### IEEE802.3 4P Task Force Channel Pair To Pair Resistance Imbalance (End to End System Imbalance) Ad Hoc July 2014

Meeting #1: Rev\_001 Monday February 17, 2014 Meeting #2: Rev\_001b Monday February 24, 2014 Meeting #3: Rev 004, Thursday April 24, 2014 Meeting #4: Rev 005, Thursday May 1, 2014 Meeting #5: Rev 006, Thursday May 8, 2014 Meeting #5: Rev 008, Thursday May 8, 2014, Ad-hoc report for May 2014 meeting. Meeting #6: Rev 009, Thursday May 15,2014, Norfolk VA. Meeting #7: Rev 010, Tuesday June 10, 2014, Meeting #8: Rev 011a, Tuesday June 24, 2014. Meeting #9: Rev 012b, Tuesday July 1, 2014. Adhoc report for July 2014 San Diego Rev 013.

# Adhoc report – July 2014

### IEEE802.3 4P Task Force Channel Pair To Pair Resistance Unbalance (CP2PRUNB) (only cables and connectors) Analysis of ad-hoc proposed use cases

#### For Channel P2PRUNB:

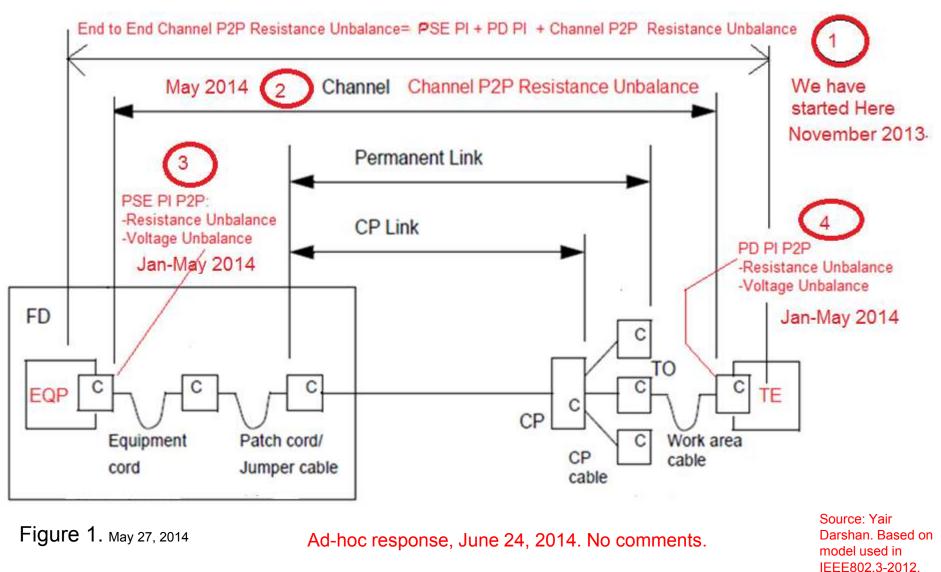
-Variable Channel Length, number of connectors up to 4.

-A single maximum number representing maximum C\_P2PRunb. (Target 7.5% (TBD) or  $0.1\Omega$  which ever is greater. See details in Annex K.

- Channel is capable of reducing the end to end unbalance as function of channel length.
  - PSE PI and PD PI need to be better than the channel maximum P2PRUNB.
    - PSE PI and PD PI needs larger unbalance range than channel P2PRUNB to allow different implementations

Ad-hoc response, July 1, 2014. TBD

### Channel P2PRUNB vs. Cable resistance and connectors

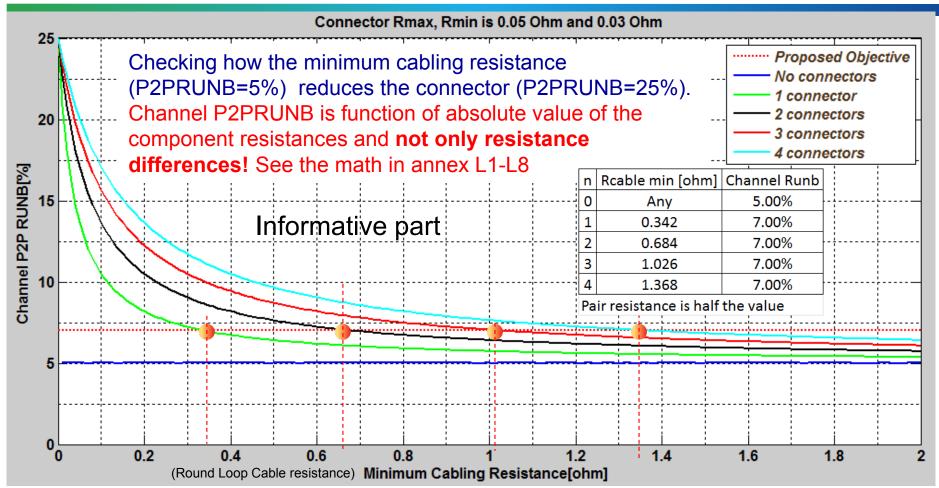
- Connector P2PRunb=100%\*(50-30)/(50+30)=25%
- Cable P2PRUNB=5%.
- Channel P2PRUNB: See 5 curves with different connector numbers

### Annex K11 Use case analysis results – Sanity Check -1 Zooming on the peaks by *Changing X axis for Cabling Minimum resistance*

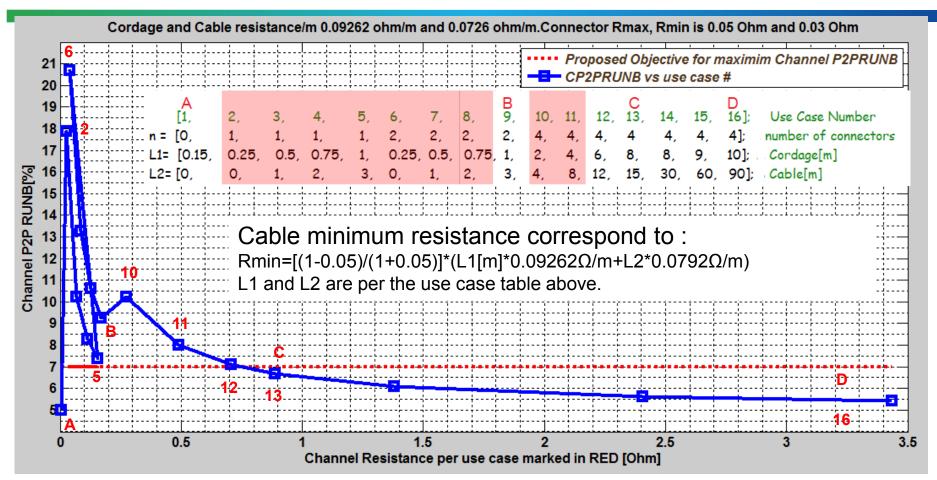
- Unrealistic use cases are now concentrated in minimum cabling resistance region.
- 0.7Ω minimum cabling resistance for a channel with 4 connectors, is required to reduce all CP2PRUNB peaks to below 7% (L1+L2~=12m total per use case # 12 in the table above).
- We may not need to require minimum channel length of 12m however it is nice to know that above 12m the channel is acting as ballast resistor to the PSE and PD PI.

### Annex K12 Use case analysis results – Sanity Check -2

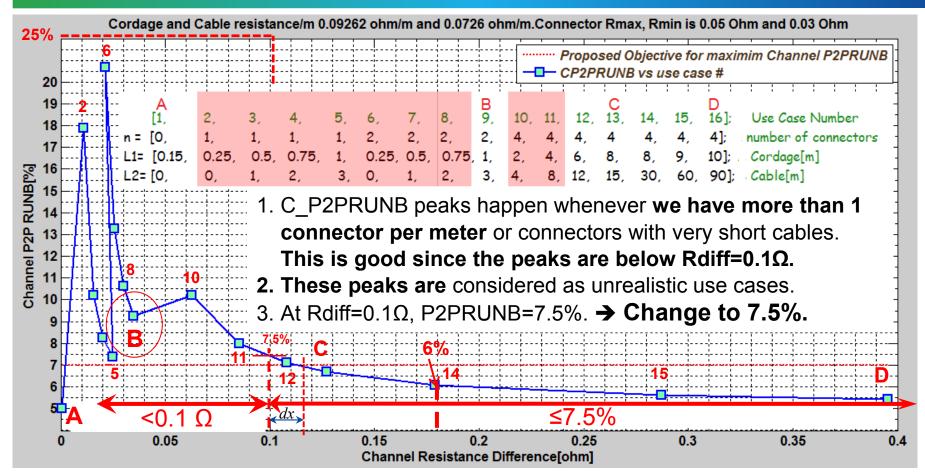
- The realistic use cases A,B,C, and D looks good. B is below Resistance Difference=0.1Ω
- Rdiff is increased as cable total resistance is increased. As a result Rdiff alone cannot be used for specifying the channel we must have the C\_P2PRUNB[%] too as expected.
   See Annex L7-L8 for details.

#### Channel P2PRUNB use cases vs. Cable resistance per meter.

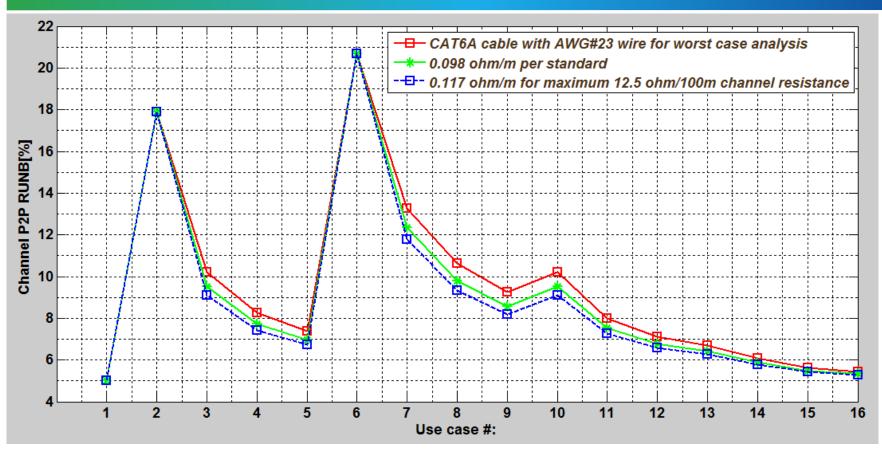
- As can be seen, CAT 6A cable with AWG#23 need to be selected for worst case analysis.
  - When we analyze the end to end Channel P2PRUNB, the 0.117Ω/m will be used too for generating maximum channel current.
- Standard value 9.8Ω/100m is maximum value which is between the two other cables. As a result, it will not be used for the purpose of this work.

#### Use case analysis results with connector Rdiff=0.015 $\Omega$ instead 0.02 $\Omega$ .

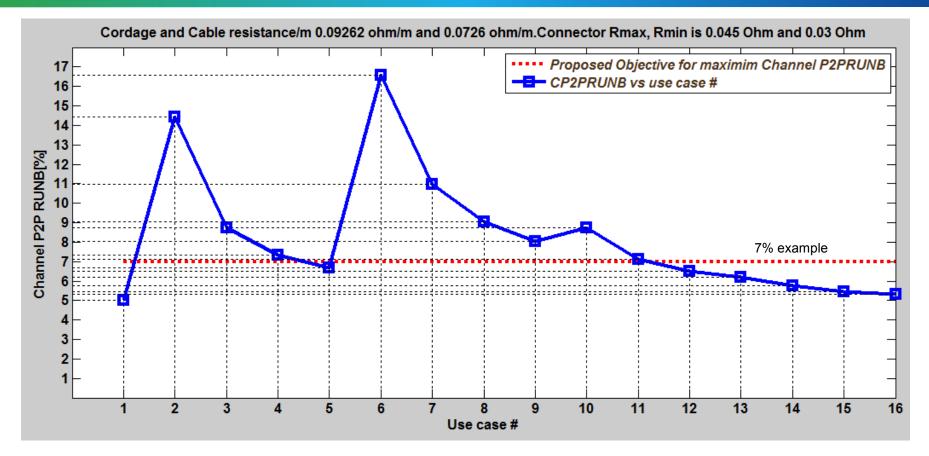
Lower peaks received with using connector Rdiff=0.015Ω instead of 0.02 Ω compared to previous run.

# Use case analysis results with connector Rmax=0.2 $\Omega$ Rdiff=0.05 $\Omega$ -2 C\_P2PRUNB vs Rdiff

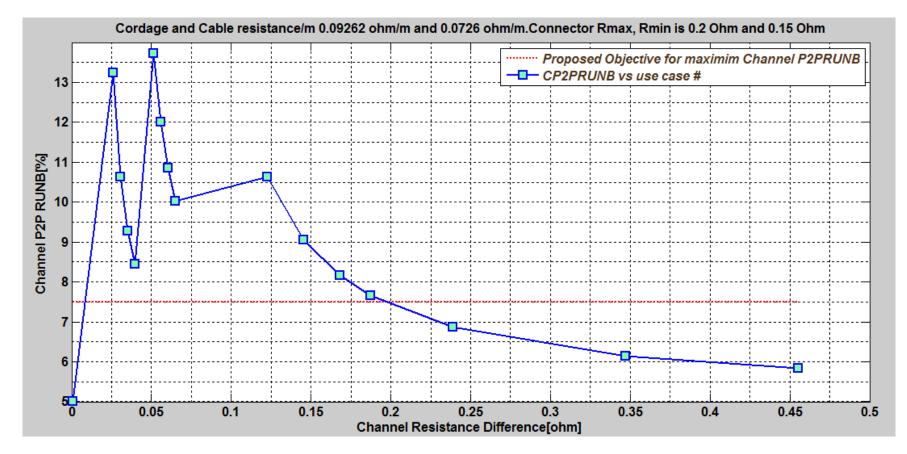
Confirming that using connector maximum standard numbers contradicts P2P Rdiff=0.1Ω. It generates higher peaks above Rdiff=0.1Ω and requires ~10.5% C\_P2PRUNB definition instead of 7.5% at Rdiff=0.1Ω which is highly unlikely to happen per connector data and process evaluation when converting process parameters (mean, sigma etc.) of Rmax=0.2Ω Rdiff=0.05Ω to actual worst case minimum/maximum/Rdiff of connectors used in this work (0.05/0.2 → 0.02/0.06. See worst case data base)

#### Previous work: Using setup that filters unrealistic use cases -1

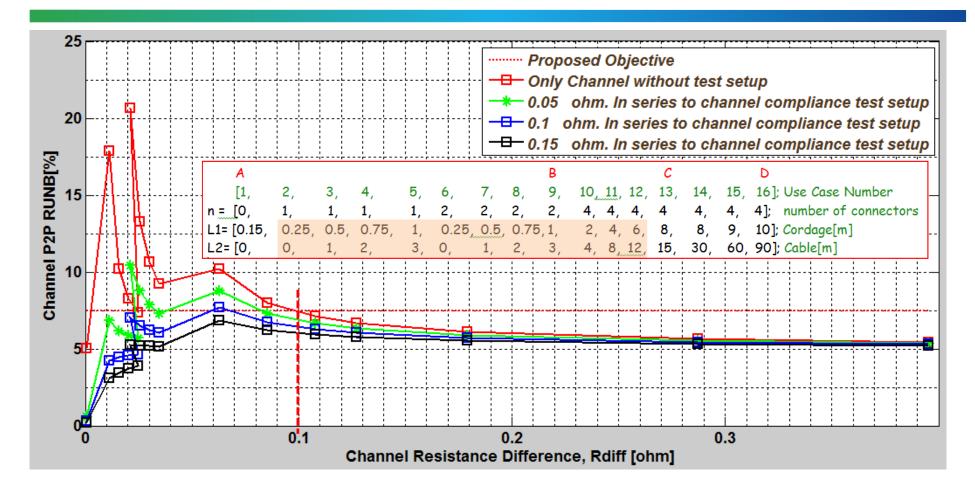
- All peaks of unrealistic use cases of the channel is located below Rdiff=0.1Ω.
- This is inline with the rational of 7.5% or 0.1  $\Omega$  which ever is greater.
- The peaks are filtered when channel is tested with some minimum resistance.

#### Previous Work: Using setup that filters unrealistic use cases -2

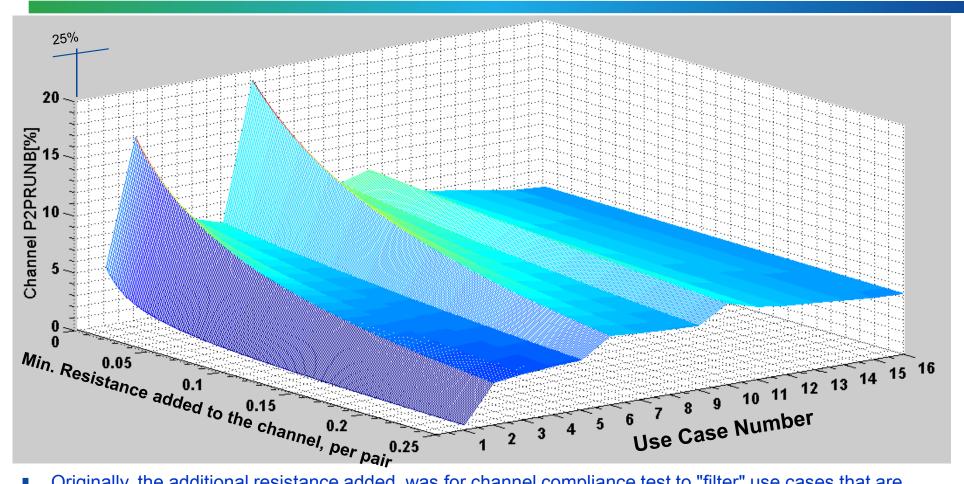
Originally, the additional resistance added, was for channel compliance test to "filter" use cases that are considered as "not typical". Further work showed that the set up may not be required since realistic use case such B is falling into Rdiff=0.1Ω max while the other realistic use case falls within the 7% proposed limit. More over below Rdiff=0.1Ω max, the C\_P2PRUNB is bounded by connectors Runb=25% per the worst case data used in this work

#### Previous Work: Using setup that filters unrealistic use cases -3

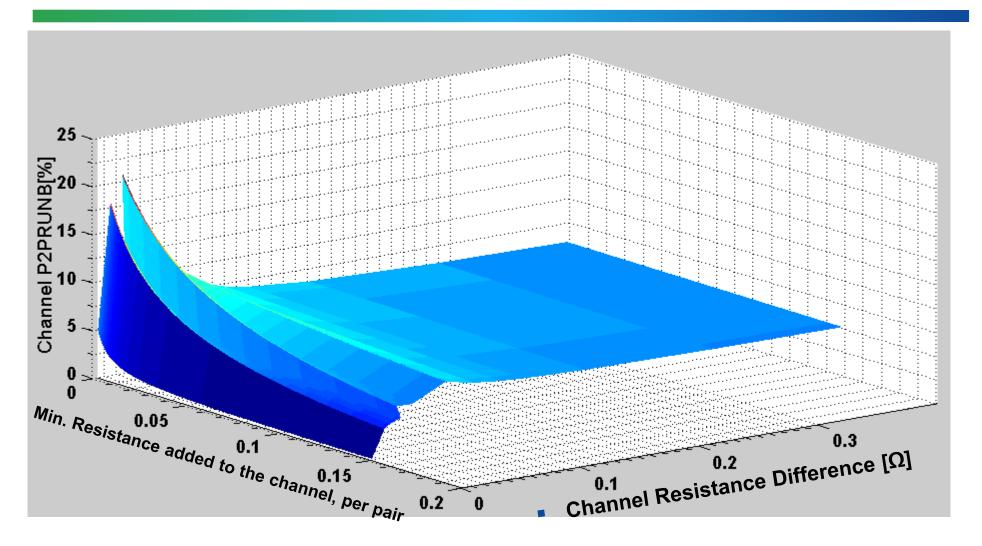
We can see that all peaks are located below 0.1 ohm requirement. As a result, setup may not be required. P2PRUNB and Rdiff cover all use cases.

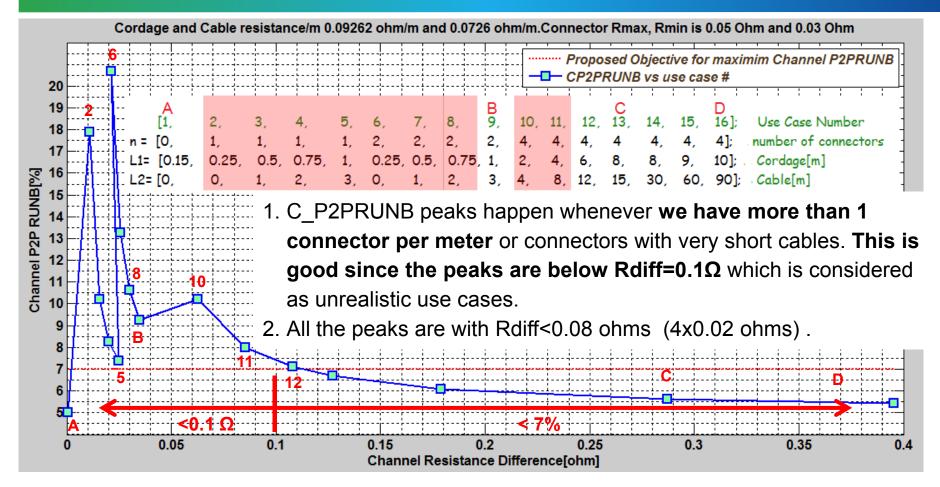
- If we specify PSE PI by only Rdiff and Vdiff we will have the following interoperability issues:
- Examples:
- Rdiff=Rmax-Rmin=0.2=X:
  - P2PRUNB=(0.2-0)/(0.2+0)=100%
  - P2PRUNB=(0.23-0.03)/(0.23+0.03)=77%
  - P2PRUNB=(0.3-0.1)/(0.3+0.1)=50%
  - P2PRUNB=(1-0.8)/(1+0.8)=11%

Interoperability Issue: Different UNBALANCE For the same Rdiff resulting With different Imax for the Same channel and PD
